BROWNS FERRY NUCLEAR PLANT (BFN) - UNITS 2 AND 3 - TECHNICAL SPECIFICATIONS (TS) CHANGE TS-418 - REQUEST FOR EXTENDED POWER UPRATE OPERATION- RESPONSE TO NRC REQUESTS FOR ADDITIONAL INFORMATION REGARDING CREDIT FOR CONTAINMENT OVERPRESSURE (TAC NOS. MC3743 AND MC3744)

RESPONSE TO QUESTION SPSB-A.11
FROM NRC LETTER DATED OCTOBER 3, 2005

NRC Request SPSB-A.11

FIGURE SPSB-A.11-1: NPSH REQUIREMENTS FOR DBA LOCA - SHORT TERM

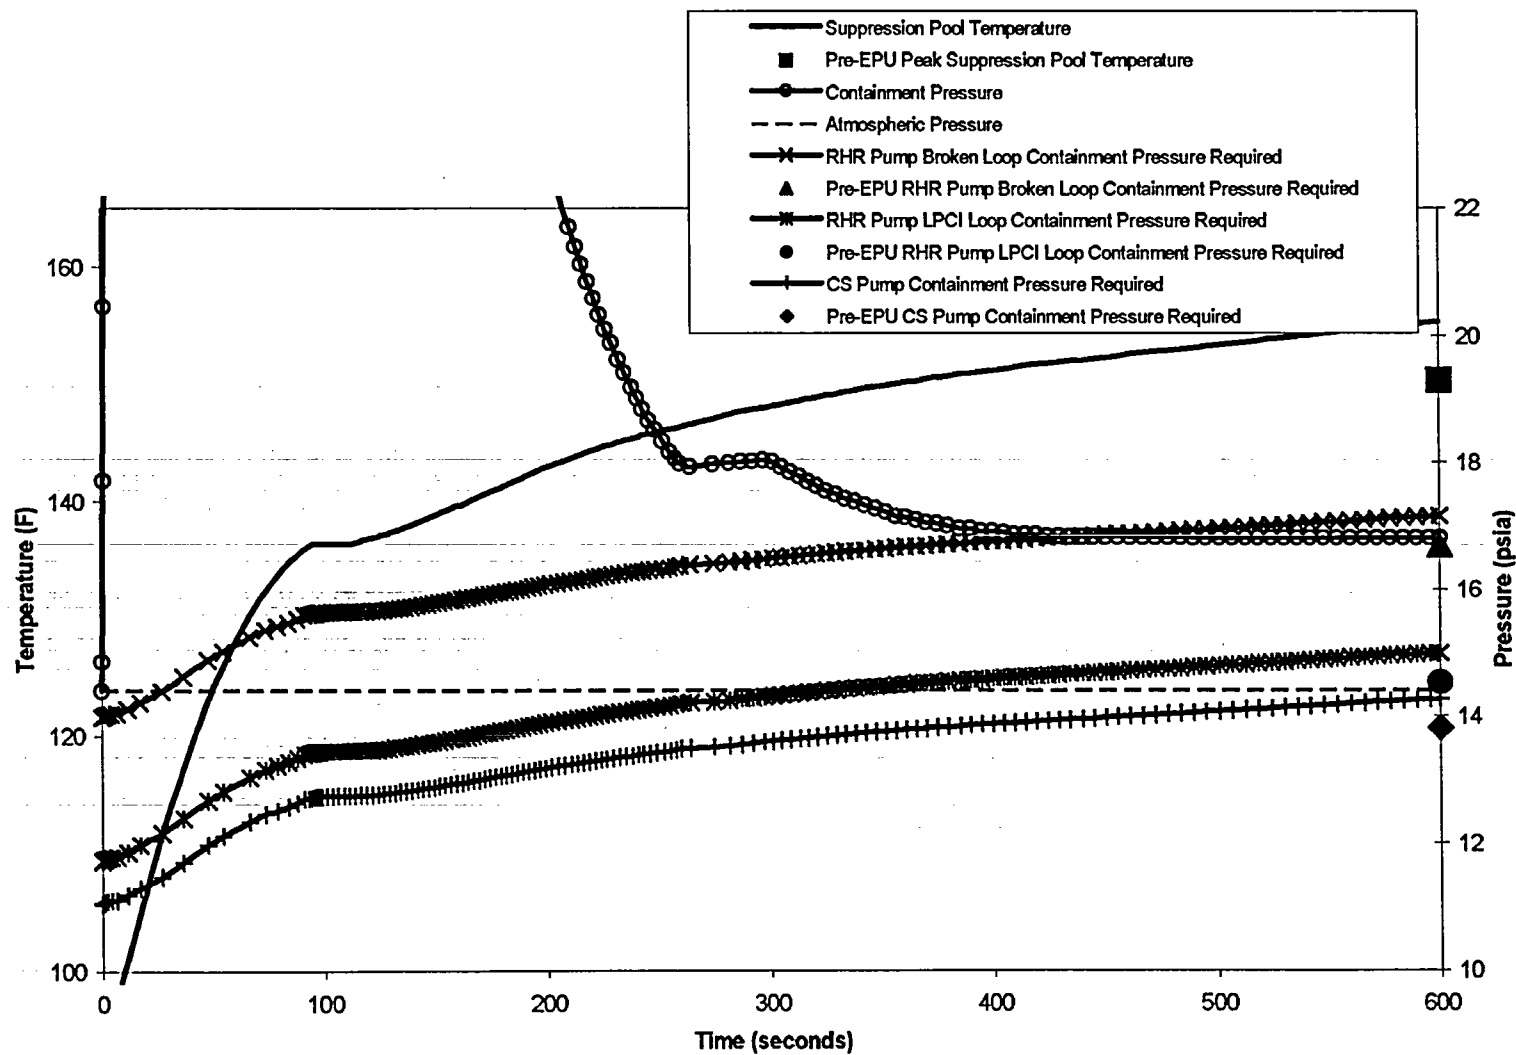
Considering the above discussion, please provide an assessment of the credit for containment accident pressure against the five key principles of risk-informed decision making stated in RG 1.174 and SRP Chapter 19. Specifically, demonstrate that the proposed containment accident pressure credit meets current regulations, is consistent with the defense-in-depth philosophy, maintains sufficient safety margins, results in an increase in core-damage frequency and risk that is small and consistent with the intent of the Commission's Safety Goal Policy Statement, and will be monitored using performance measurement strategies. With respect to the fourth key principle (small increase in risk), provide a quantitative risk assessment that demonstrates that the proposed containment accident pressure credit meets the numerical risk acceptance guidelines in Section 2.2.4 of RG 1.174. This quantitative risk assessment must include specific containment failure mechanisms (e.g., liner failures, penetration failures, primary containment isolation system failures) that cause a loss of containment pressure and subsequent loss of NPSH to the ECCS pumps.

The bounding design basis event for determining NPSH margin is a double ended recirculation discharge line break. This event results in maximum suppression pool temperature and maximum total pump flow. The discharge line break is chosen because the low system resistance on the broken line produces the most limiting flow and NPSH for two RHR pumps which are assumed to be pumping into the broken line inside containment. At the beginning of the event, four RHR pumps and four CS pumps start automatically and align to inject to the Reactor Pressure Vessel (RPV). Two RHR pumps inject to the RPV at 10,000 gpm each, two RHR pumps inject through the broken line into the containment at 11,000 gpm each (greater than design flow), and four CS pumps inject to the RPV at 3,125 gpm each. This mode of operation is assumed for 10 minutes consistent with not crediting operator action for 10 minutes. ECCS strainers are assumed to accumulate the maximum equilibrium debris load. During this time, suppression pool temperature reaches 155.4°F, and only the RHR pumps require credit for COP in order to have sufficient NPSH margin as shown in Figure SPSB-A.11-1.

By comparison to the RHR pumps, the CS pumps would be challenged in the long-term scenario in the event that COP was lost. CS pumps do not require COP in the short-term (Refer to Figure SPSB-A.11-1). BFN CS pumps are Sulzer-Bingham model 12x16x14.5 CVDS. Assuming no credit for COP, the CS pumps used for long-term core cooling (>10 minutes) would be expected to operate between 27 feet and 21.2 feet of NPSH verses 27 feet used in NPSH calculations for approximately 17.1 hours as suppression pool temperature peaks above 171°F during the LOCA. In the unlikely event they become degraded, there is a reasonable likelihood that the affected pumps would still be able to function. In addition, only one of the two CS loops is required to be operated for adequate core cooling and the non-operating CS loop would be available to operators if the operating loop failed after some time period. RHR pumps would also be available in the LPCI mode for core cooling in conjunction with their suppression pool cooling function should all CS pumps become unavailable. COP is not required for RHR pumps in the long-term scenario. Therefore, in the unlikely event that COP was lost in the long-term LOCA, the decay heat removal and core cooling functions would be maintained.
